Access Compliance Report

Public Rights-of-Way

(Curb Ramps)

Intersection ID: 11164	Main Street: CAMP_GREENE_ST	Cross Street: FREEDOM_DR	Location:	W
ADA ID: A3113472DD60	Ramp Type: BlendTrans1	Initial Pass/Fail: Fail	Overall Compliance: No	Severity Score: 10
Codes/Mitigation Info/Possible Solution		Field Measurements/Component Compliance

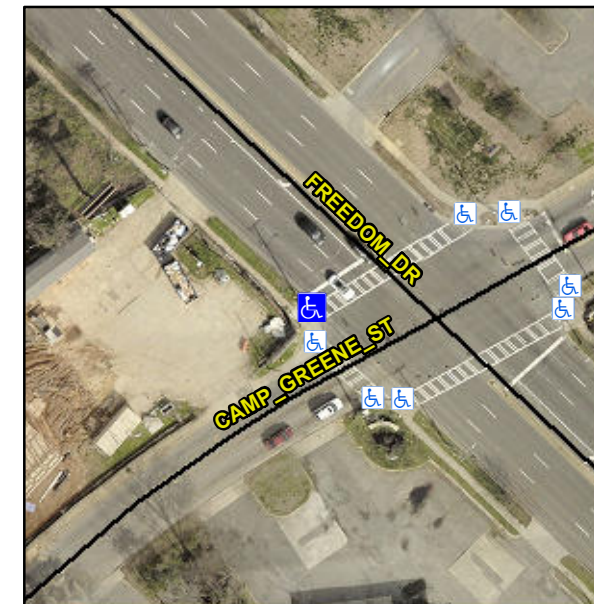
CURB GAP 2.0

PROW/ADA:

R304.5.1, R304.5.3

Compliance	Description	Data	Compliance	Description	Data
N/A	Ramp Length (in)	96.0	Yes	BlendTrans Slope (%)	4.7
No	Ramp Width (in)	47.5	No	BlendTrans XSlope (%)	5.0
N/A	Flare Type LT	N/A	N/A	Flare Type RT	N/A
N/A	Flare Slope LT (%)	N/A	N/A	Flare Slope RT (%)	N/A
N/A	Flare Traversable LT?	N/A	N/A	Flare Traversable RT?	N/A
N/A	Landing Length (in)	N/A	N/A	DWS Provided?	N/A
N/A	Landing Width (in)	N/A	N/A	DWS Contrast?	N/A
N/A	Landing Slope (%)	N/A	N/A	DWS Length (in)	N/A
N/A	Landing X Slope (%)	N/A	N/A	DWS Full Width?	N/A
N/A	Landing Curb? (Y/N)	N/A	N/A	DWS Offset (in)	N/A
N/A	Shared Landing?	N/A			
N/A	Gutter Ponding?	N/A	N/A	Gutter Slope (%)	N/A
N/A	Gutter Lip Ht (in)	N/A	N/A	Gutter X Slope (%)	N/A
N/A	Painted X Walk1?	Yes	N/A	Painted X Walk2?	N/A
	X Walk 1 Direction	To NE		X Walk 2 Direction	N/A
	X Walk 1 Width (in)	85.0		X Walk 2 Width (in)	N/A
	X Walk 1 Slope (%)	3.4		X Walk 2 Slope (%)	N/A
	X Walk 1 X Slope (%)	2.3		X Walk 2 X Slope (%)	N/A

Remove & Replace Curb Ramp With Two New Directional Ramps or Equivalent.
